**OASIS WEST REALTY
(BEVERLY HILTON HOTEL)**

September 28, 2016 Letter to Planning Commission

Wanda Summary Document

Table of Contents for LST

WANDA LOADING DOCK ACCESS - SEMITRUCK/TRAILER STUDIES

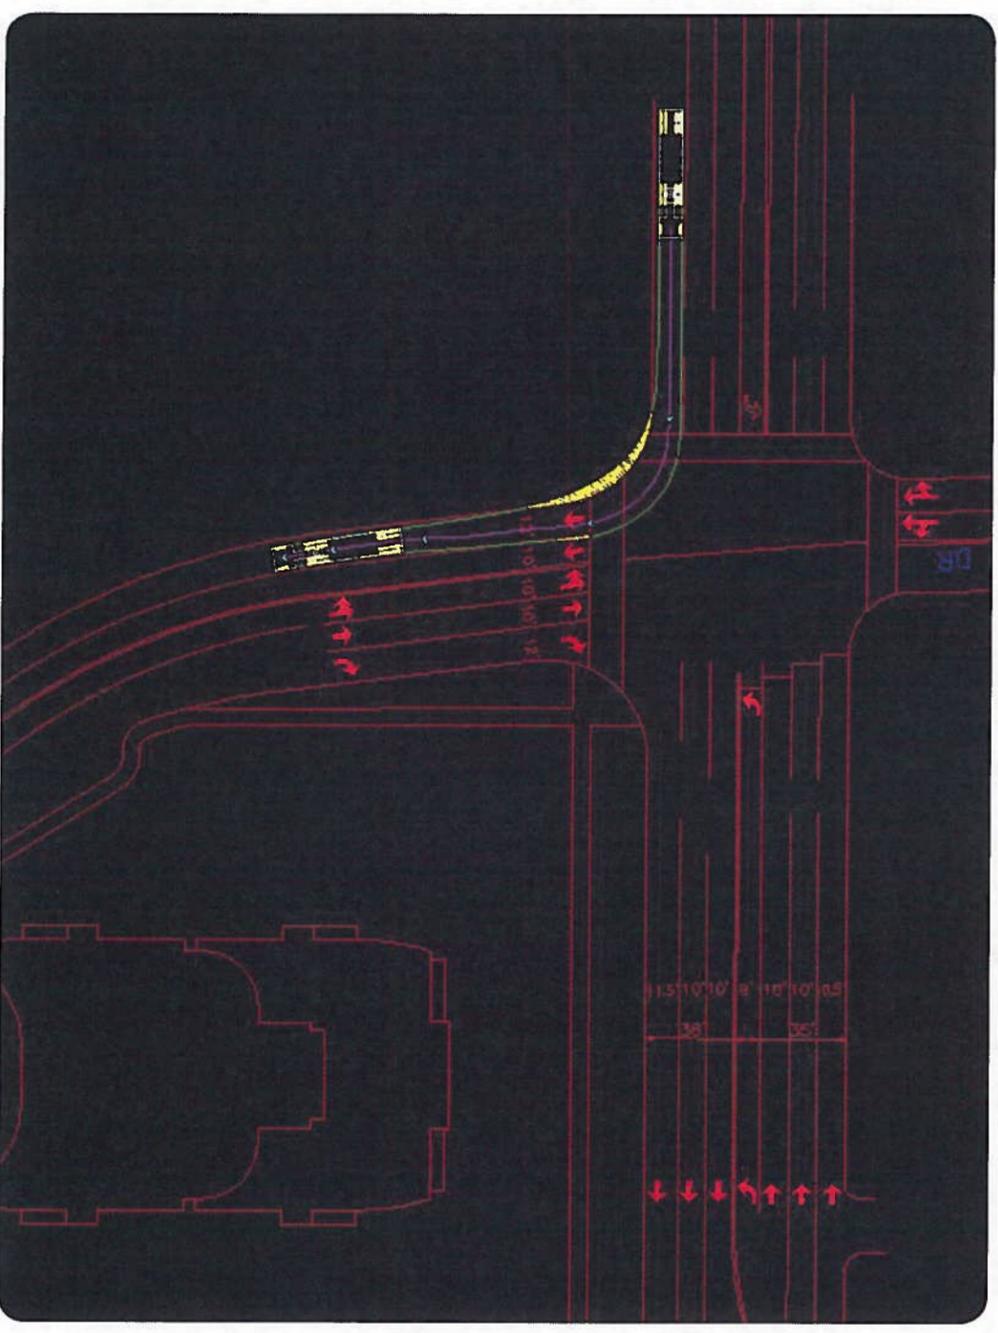
3. Large trucks trying to access or exit the Wanda loading dock proposed for Merv Griffin Way will have great difficulty accessing Merv Griffin Way. See video of actual large trucks trying to make the turn. Cars will have to move out of the way to make the turn onto Merv Griffin Way. Merv Griffin Way is not a public street and cannot handle that level of loading. See graphics of truck turn radius and inability to make turn into loading dock. Large truck turns from Merv Griffin Way into and out of the loading dock will require illegal turns crossing over another turn lane. See truck turning graphics.

5. Graphic images and animations of truck turn requirements for the Project's loading dock
 - *These images demonstrate that the service trucks entering into Wanda's proposed loading dock will need to make an illegal turn from an outside lane in order to avoid driving over the curb along Merv Griffin Way. If the trucks attempt to make the turn from the legally required lane, they must cross over the curb, creating a dangerous condition for pedestrians and other vehicles. The graphic images show that the turn radius requirements for trucks entering onto Merv Griffin Way from Santa Monica Boulevard and Wilshire Boulevard must cross into outside traffic lanes to avoid driving on the sidewalk.*

WILSHIRE BLVD./MERY GRIFFIN WAY - WESTBOUND LEFT TURN

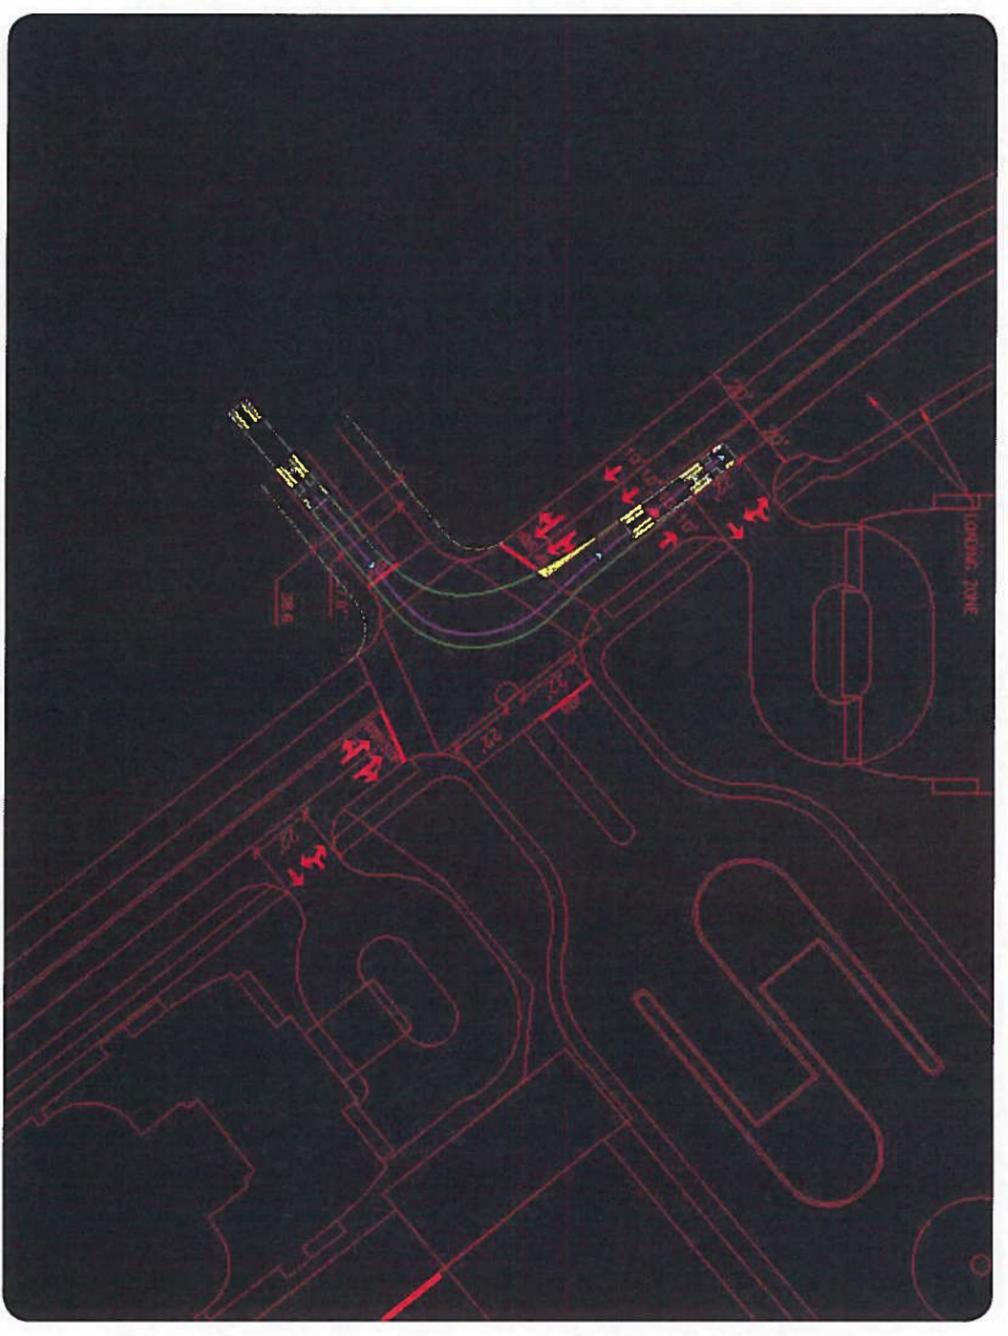
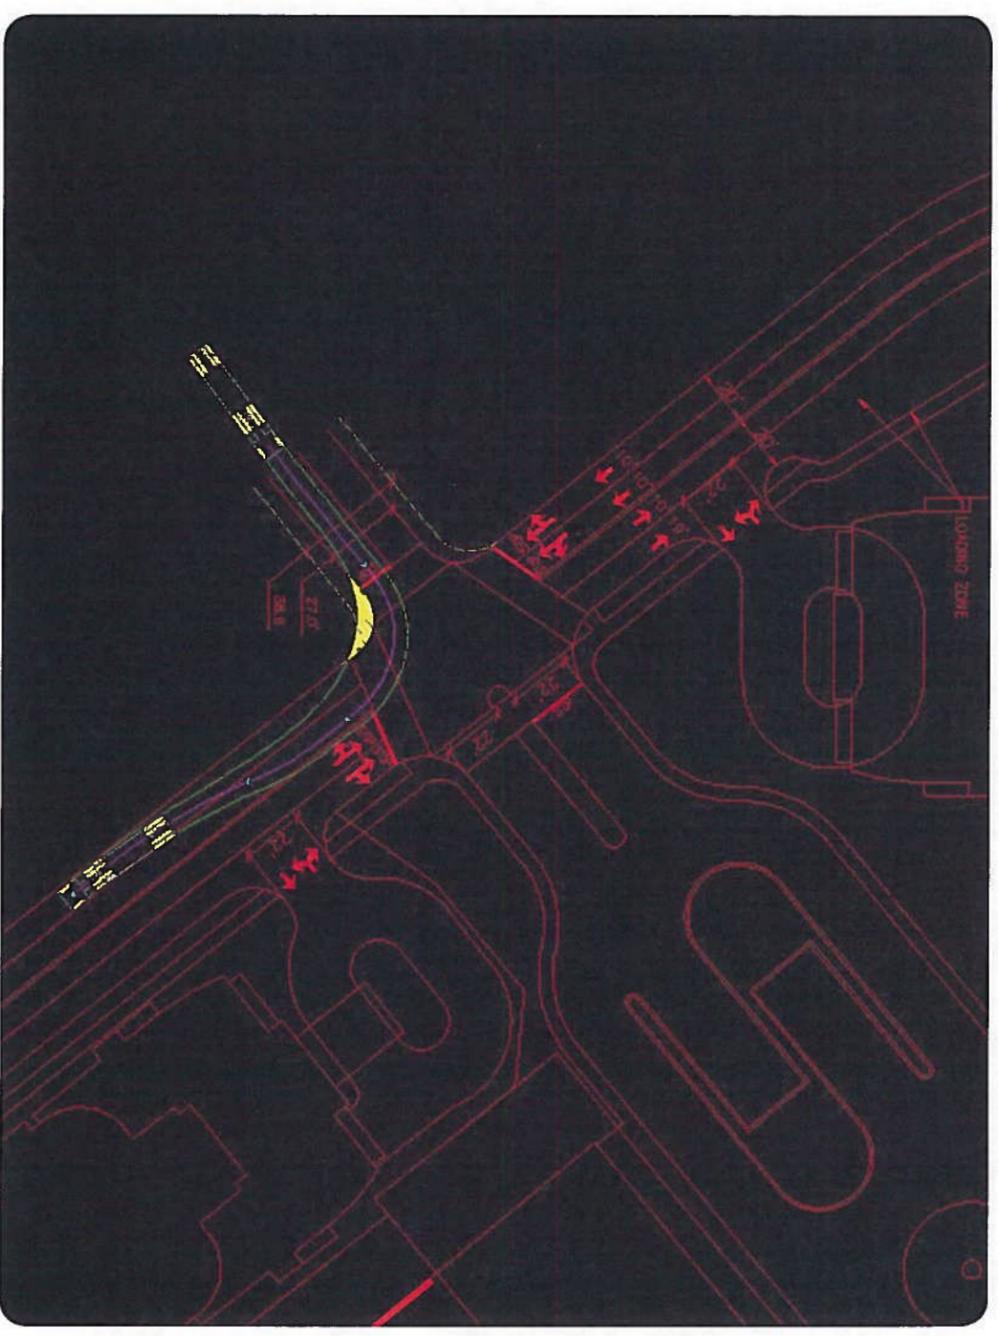
4. Video of trucks making turns onto Merv Griffin Way
 - *The videos show that to make a turn from Santa Monica and Wilshire Boulevards onto Merv Griffin Way, loading and service trucks must cross into the right-of-way for oncoming cars which will tie up traffic and create dangerous condition.*
